Colney Heath Group (CH Group)

Appeal by Brett Aggregates Limited

Land at former Hatfield Aerodrome Hatfield Hertfordshire AL4 0JB

CHG Hydrology & public access issues

A drawing from the Technical Memorandum, Principal Drainage Catchment, SWM003, note Phase A is catchment 3

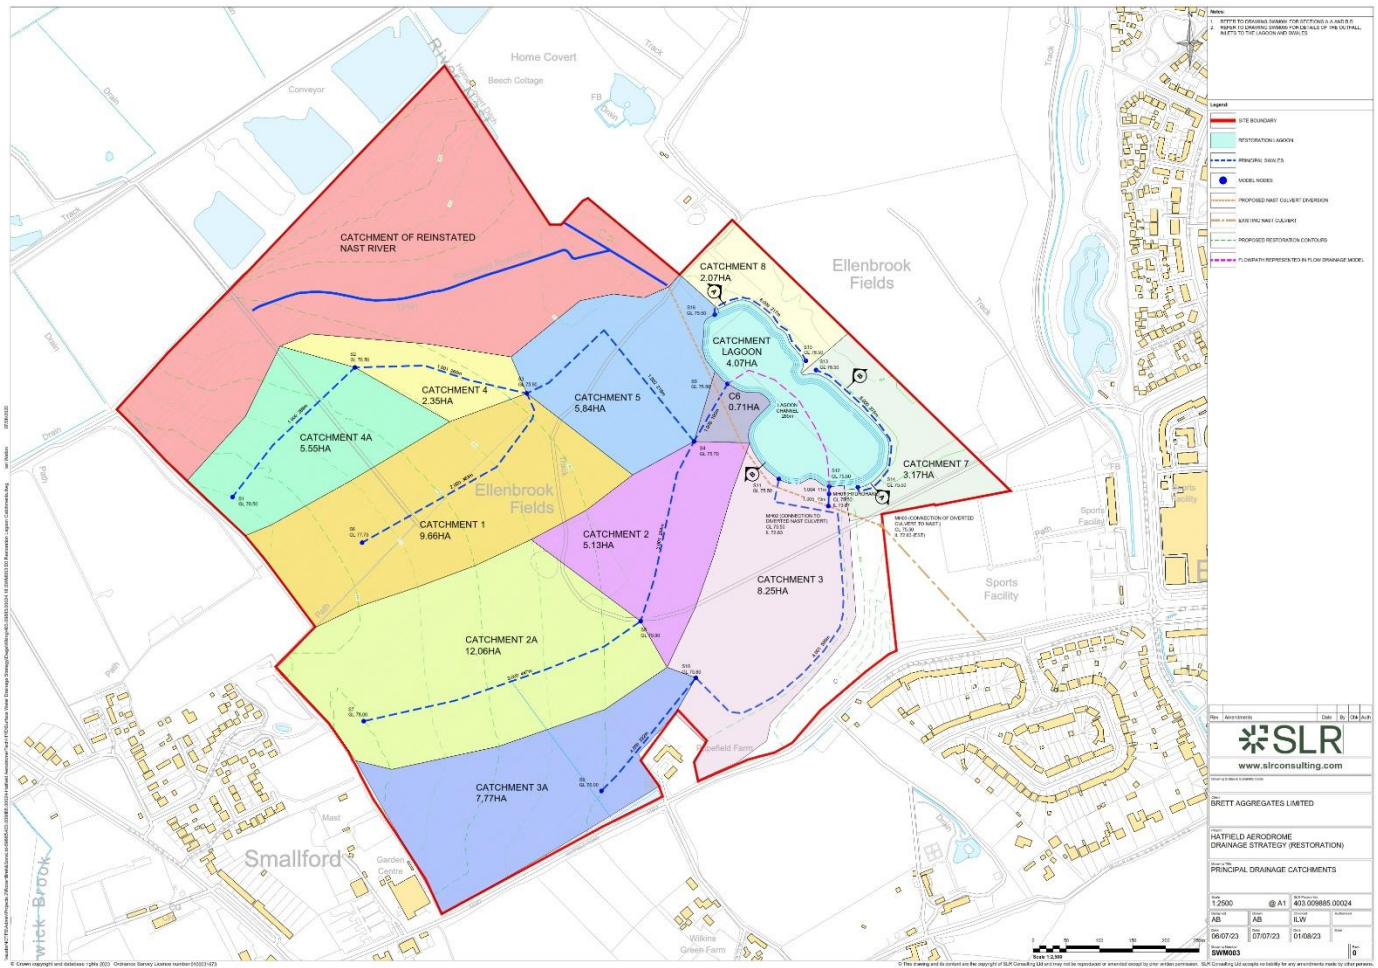
The drawing shows 5 large reedbeds (brown patches) that are part of the restoration that implies the land will be wet.
